MEMO — **10/22/2026** **SUBJECT —** Borough of Greencastle Plaza Phase 4-Addendum #3

Addendum #3 includes the following information:

Proposed Construction for
Town Hall Plaza
60 N. Washington Street
Greencastle, Pennsylvania 17225

STRUCTURAL
PLANS & NOTES

CANOPY FRAMING PLAN

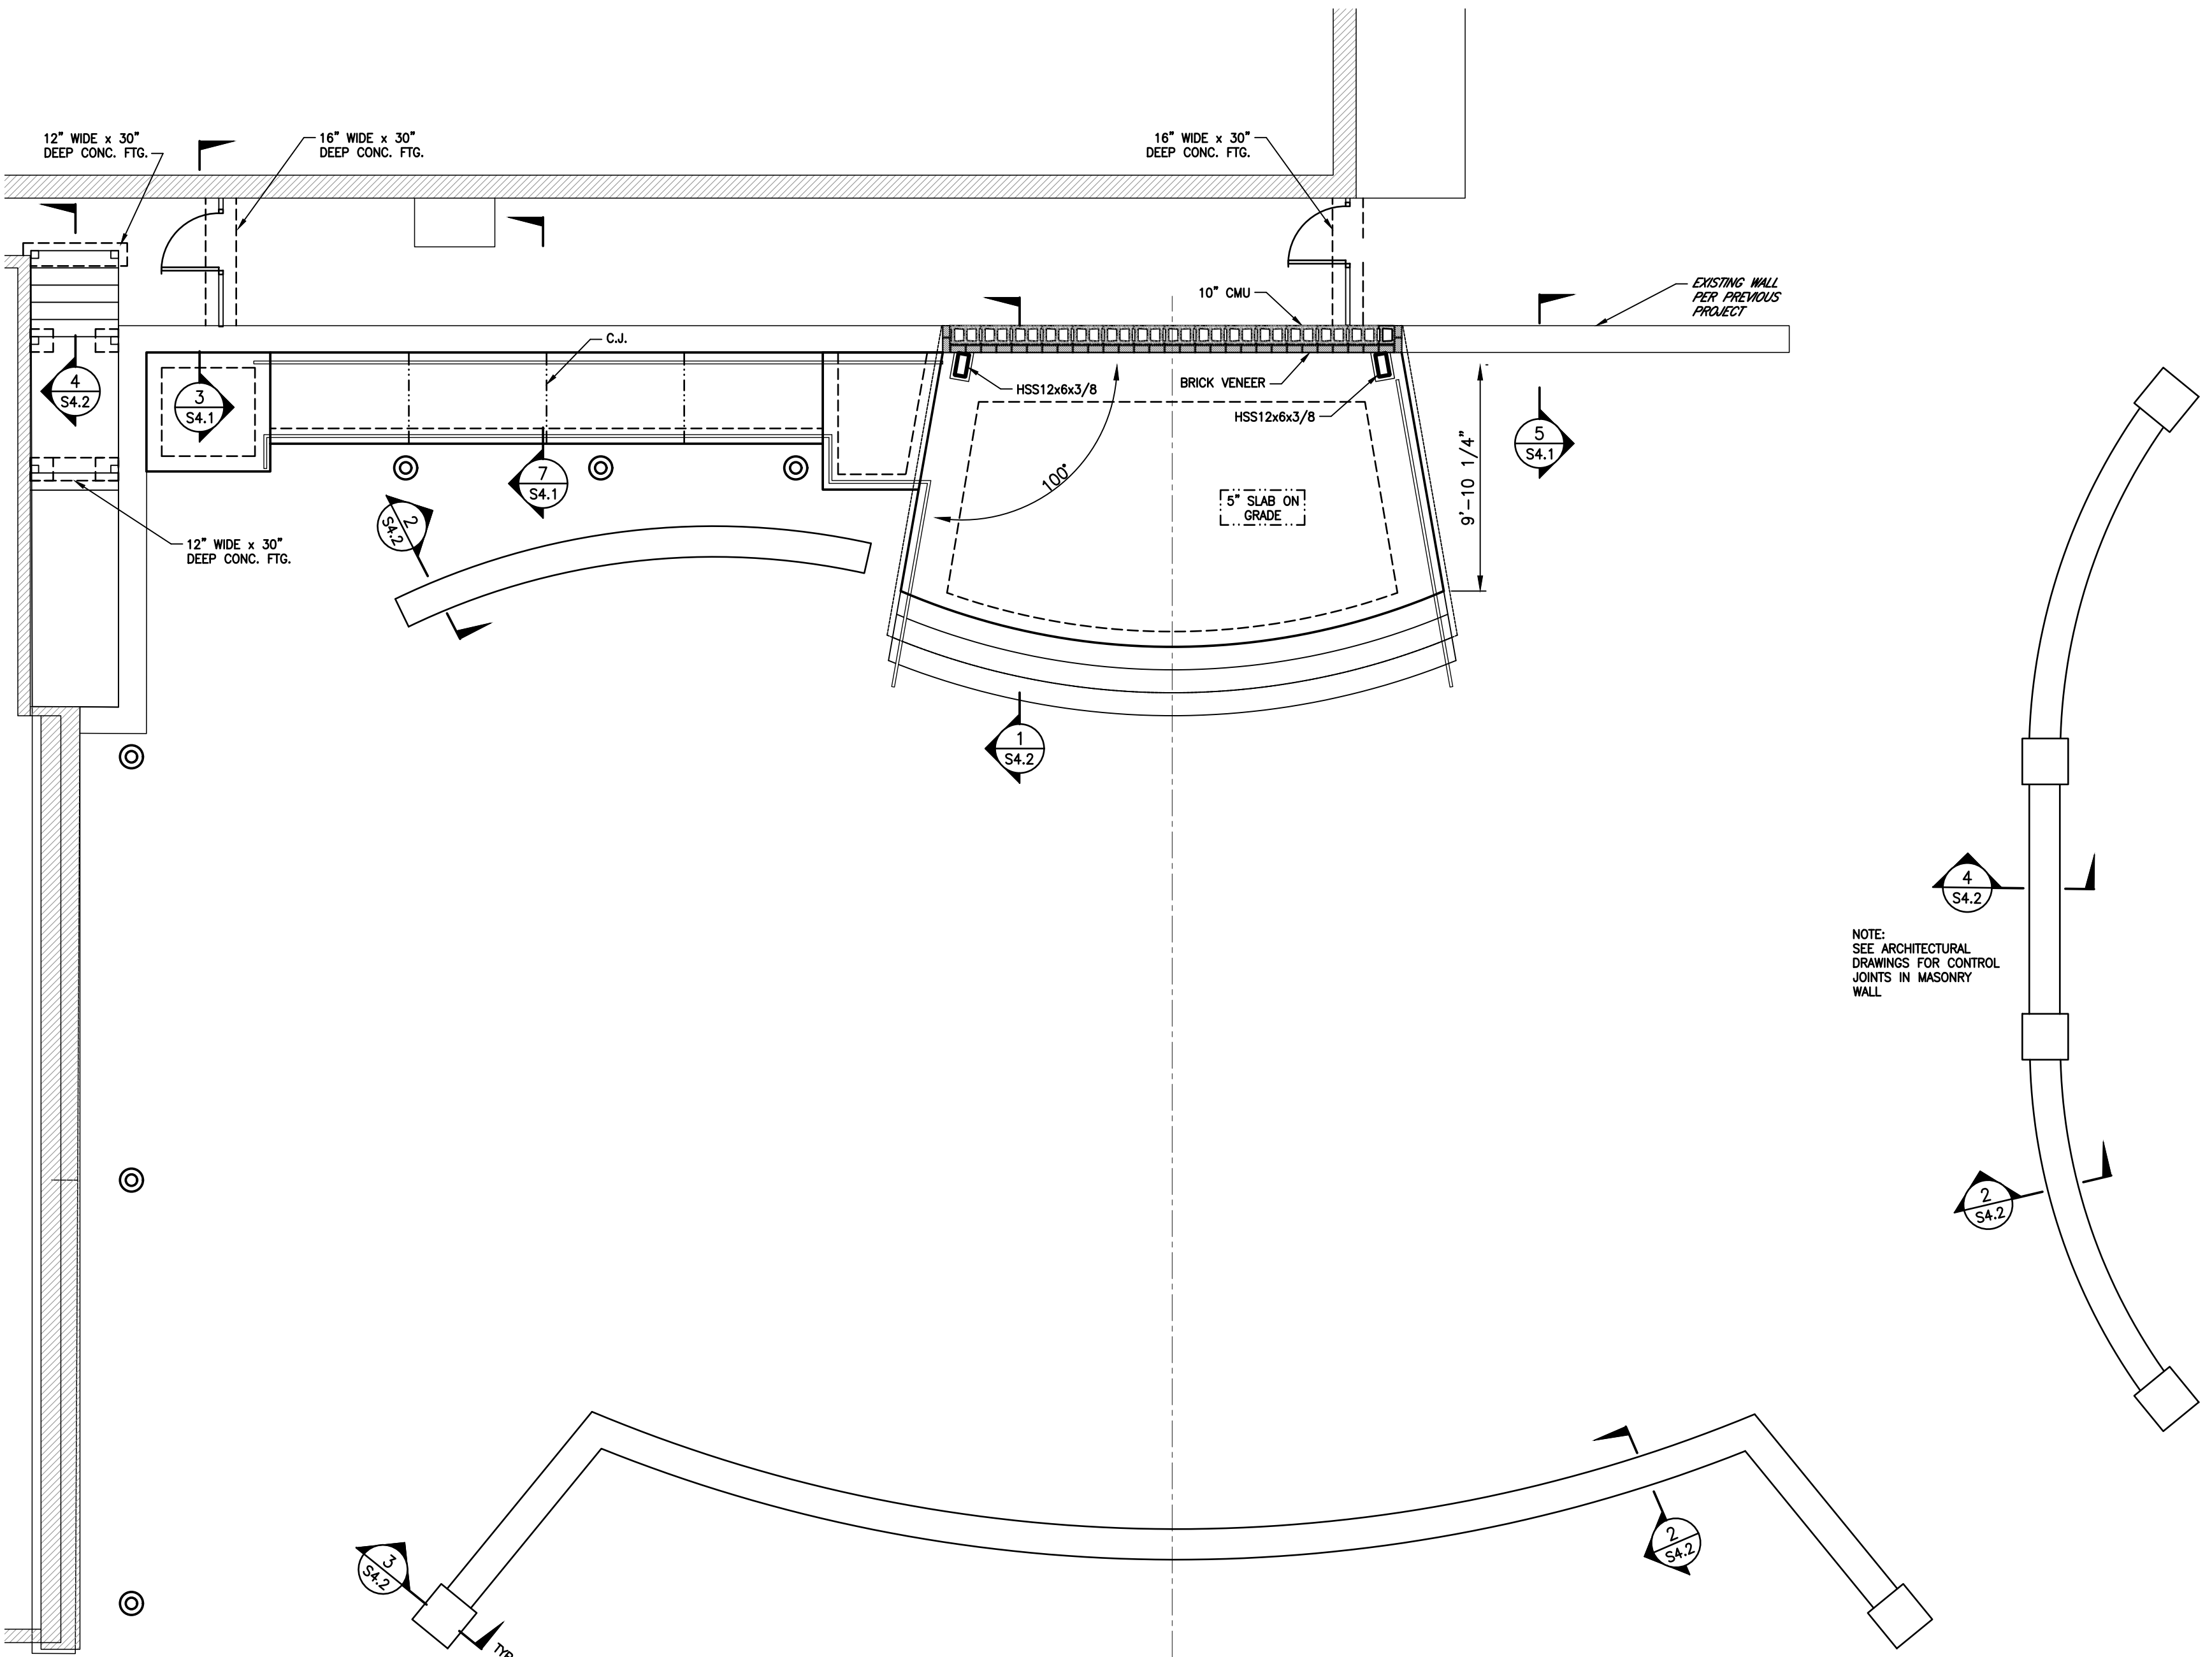
- Clarification to bidder's RFI regarding canopy steel items, clip angles, etc.
[See attached drawings](#)
